## **Questions & Answers #1-16**

### **FA2521-17-B-0014, Chiller Motion Picture Lab**

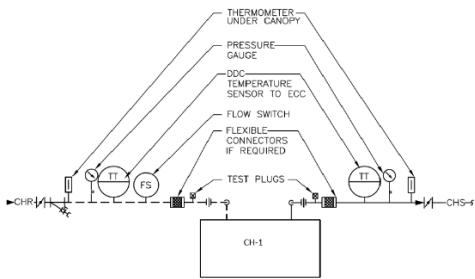
- 2) Question: Drawing M-001, Detail 1: This detail doesn't show many items typically found on chiller connections, to include: flex connects, balance valve, dP connections, strainer with blow down, test plug, drains, etc. Are we to pipe to chiller based on the provided detail?

- 3) Question: Same drawing as above: Drawing contains a piping symbol that doesn't show up on the notes and we're not certain what it's supposed to be. Please advise.

Answer: Piping shall be as follows:

Answer: See detail above
